SERVICE BULLETIN**N° 189-185****DATE:** April 9, 2019**REV. :** F - October 25, 2021

TITLE**ATA 46 - INSTALLATION OF AVIONIC FLIGHT SOFTWARE RELEASE PHASE 5.0****REVISION LOG**

This Service Bulletin is issued in order to provide the necessary instruction on how to perform the Software release Phase 5.0 installation.

Figure 7

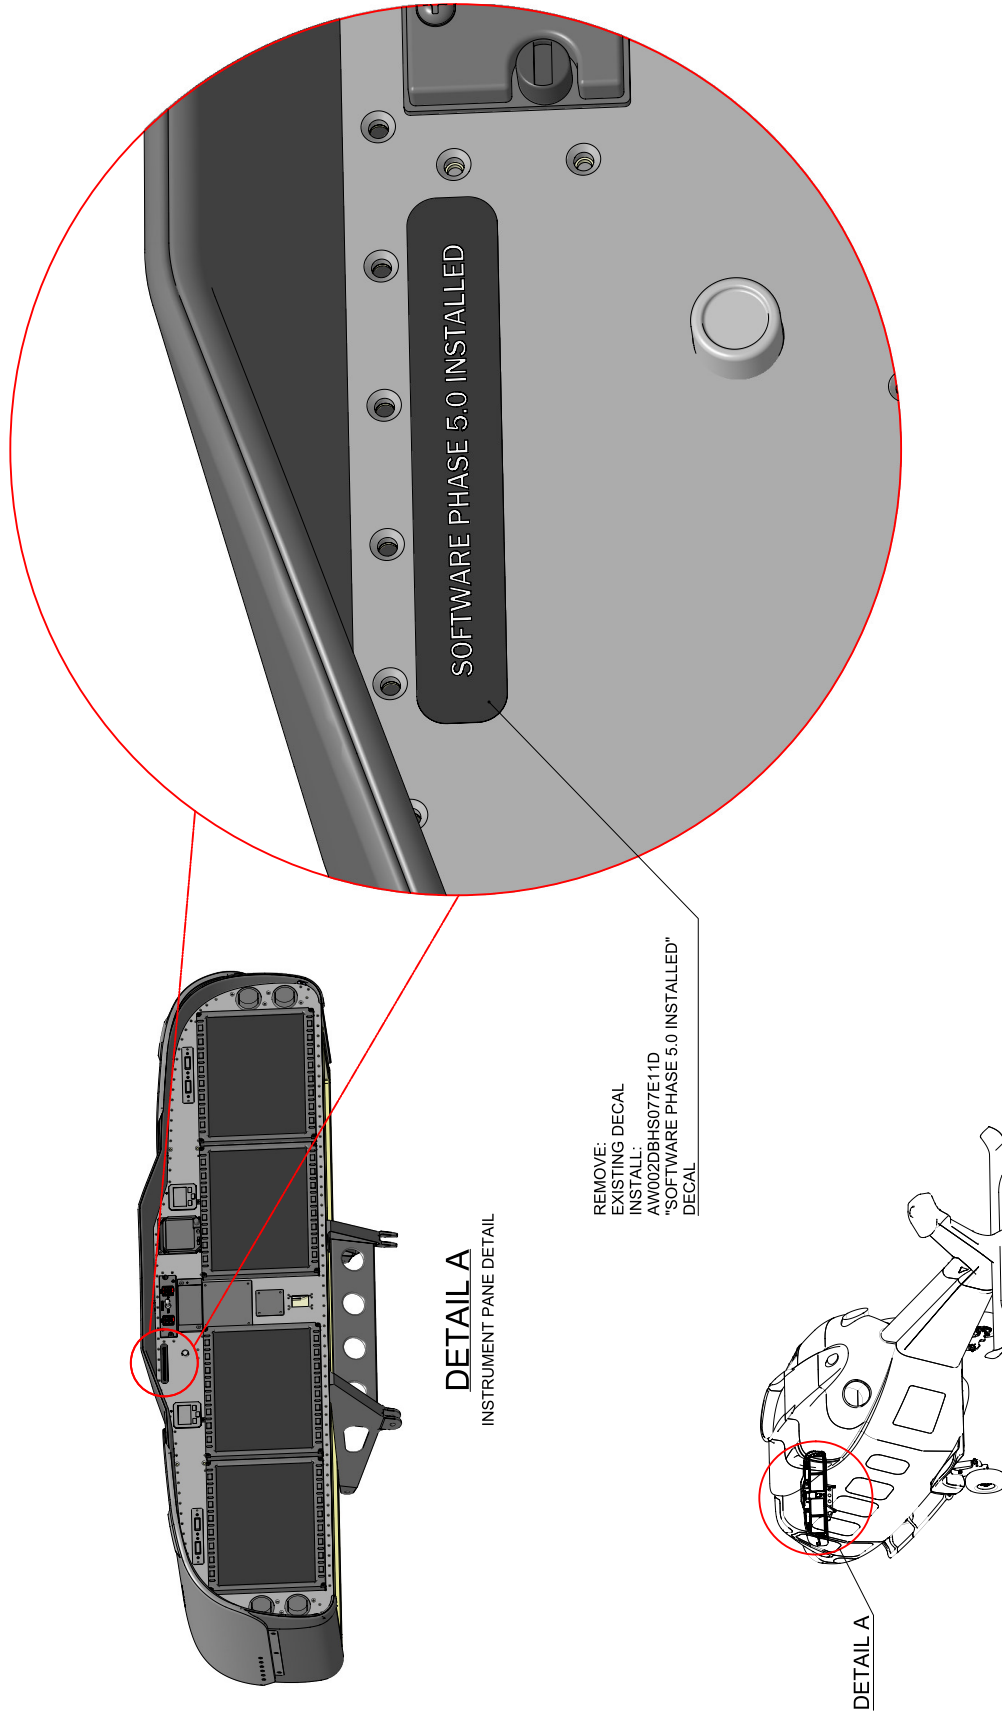
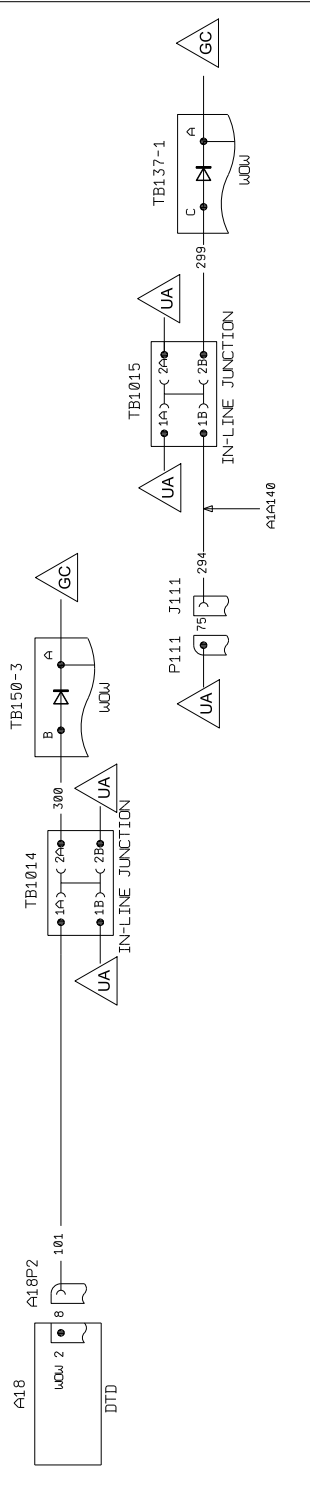
- 6.3 With reference to Figure 7 wiring diagram, perform the DTD upgrade retromod P/N 8G4600P00611 as described in the following procedure:
 - 6.3.1 From the TB1014, disconnect the pin 1A and the pin 2A; connect together the wire 4600-101-22G and 4600-300-22G by means of n°1 splice P/N M81824/1-1. Mark the splice as SP4600-001.

- 6.3.2 Cut a piece of wire P/N A556A-T22 at adequate length between TB1014 and TB150-5, following existing cable routing; crimp on each wire end a contact P/N A523A-A02 and connect the pin 1A of TB1014 with pin J of TB150-5. Install n°2 marker sleeve A579A02-002, one near each TB, and mark the wire as 4600-005.

- 6.3.3 From the TB1015, disconnect the pin 1B and the pin 2B; connect together the wire 4600-294-22G and 4600-299-22G by means of n°1 splice P/N M81824/1-1. Mark the splice as SP4600-002.

- 6.3.4 Cut a piece of wire P/N A556A-T22 at adequate length between TB1015 and TB137-5, following existing cable routing; crimp on each wire end a contact P/N A523A-A02 and connect the pin 2B of TB1015 with pin H of TB137-5. Install n°2 marker sleeve A579A02-002, one near each TB, and mark the wire as 4600-006.

Figure 8

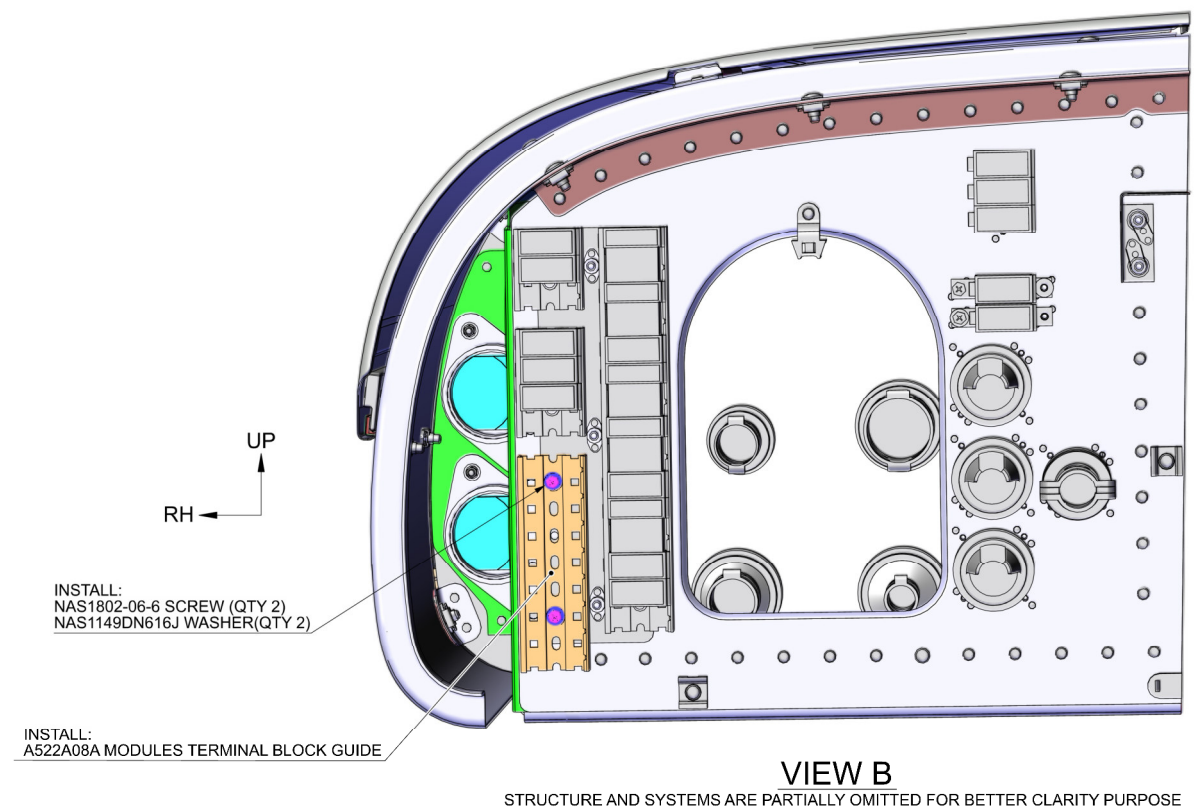
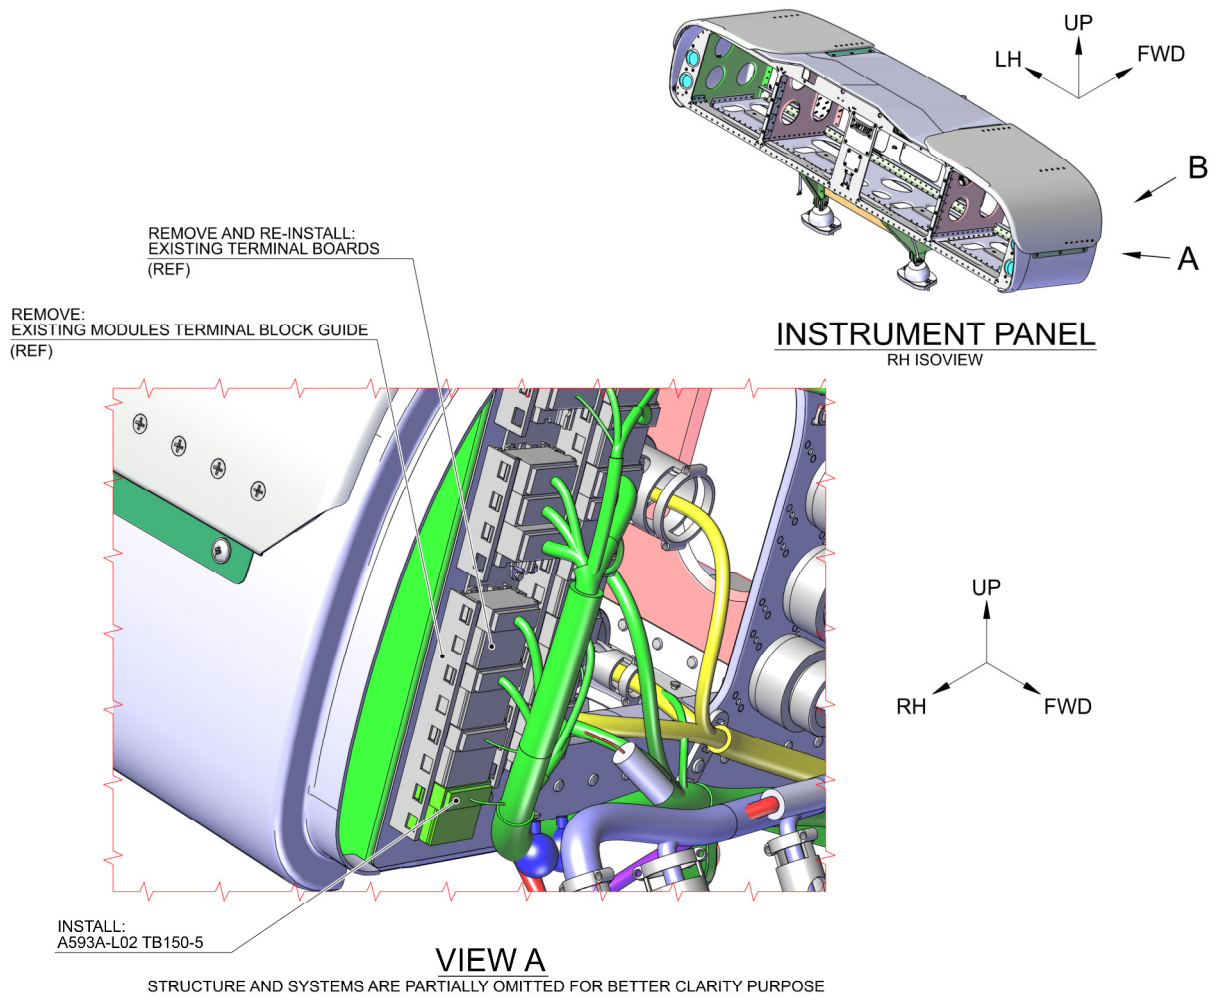
- 6.1.1 With reference to Figure 8 View A, get access to the RH aft side of the instrument panel and temporarily remove the terminal boards from the modules terminal block guide.

- 6.1.2 With reference to Figure 8 View A, remove and discard the existing modules terminal block guide.
 - 6.1.3 With reference to Figure 8 View B, install the modules terminal block guide P/N A522A08A by means of n°2 screws P/N NAS1802-06-6 and n°2 washers P/N NAS1149DN616J.

- 6.1.8 With reference to Figure 8 View A, install the terminal board TB150-5 P/N A593A-L02 on the modules terminal block guide P/N A522A08A.
- 6.1.9 With reference to Figure 8 View A, re-install the existing terminal boards previously removed.

Figure 9

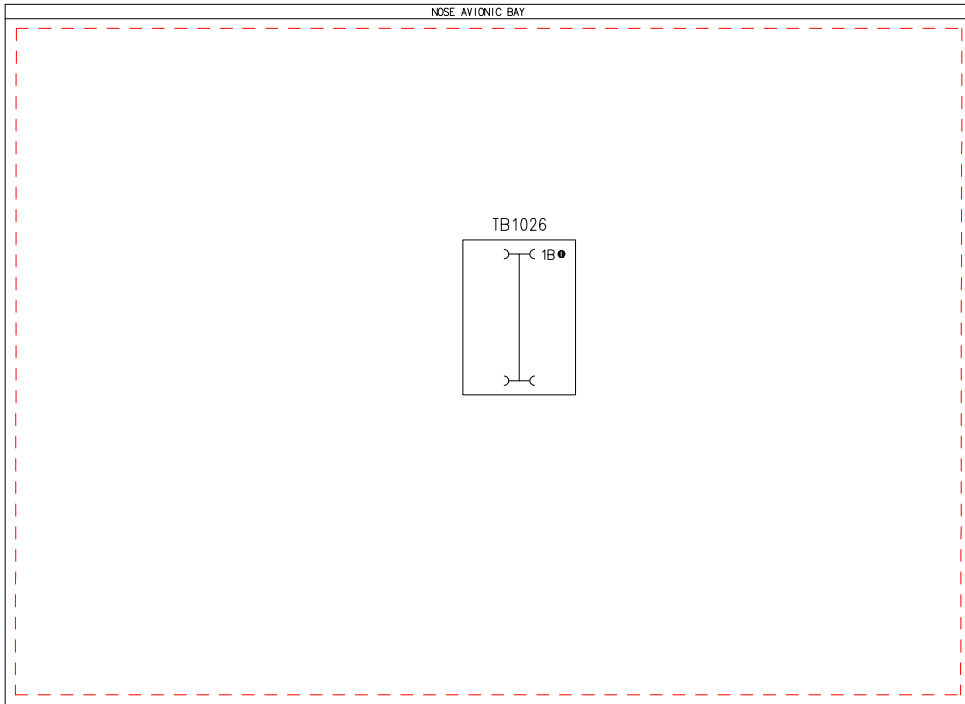
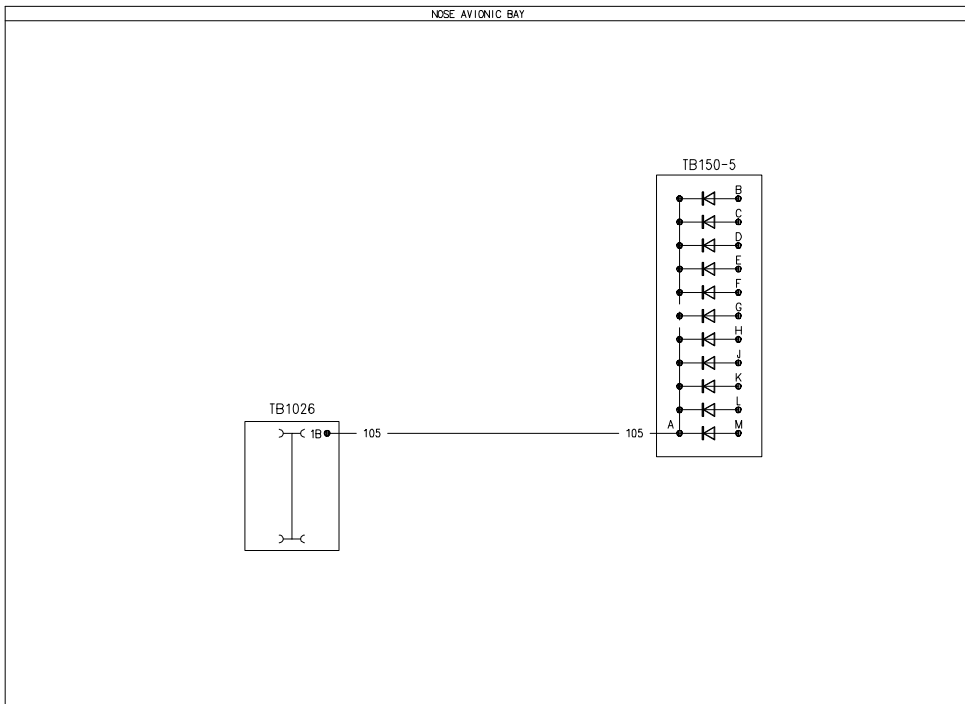
- 6.1.4 With reference to Figure 9 wiring diagram (BECOMES), cut n°1 wire P/N A556A-T22 of adequate length to allow the installation from the TB1026 to the TB150-5 P/N A593A-L02.

- 6.1.5 With reference to Figure 9 wiring diagram (BECOMES), install the electrical contact P/N A523A-A05 on TB1026 and the electrical contact P/N A523A-A02 on TB150-5.

- 6.1.6 In accordance with AMP DM 89-A-20-10-17-00A-622A-A and with reference to Figure 9 wiring diagram (BECOMES), perform the electrical connections from the TB1026 to TB150-5.

- 6.1.7 In accordance with AMP DM 89-A-20-10-06-04A-720A-A and with reference to Figure 9 wiring diagram (BECOMES), mark the cable so obtained as 105 by means of marker sleeve.
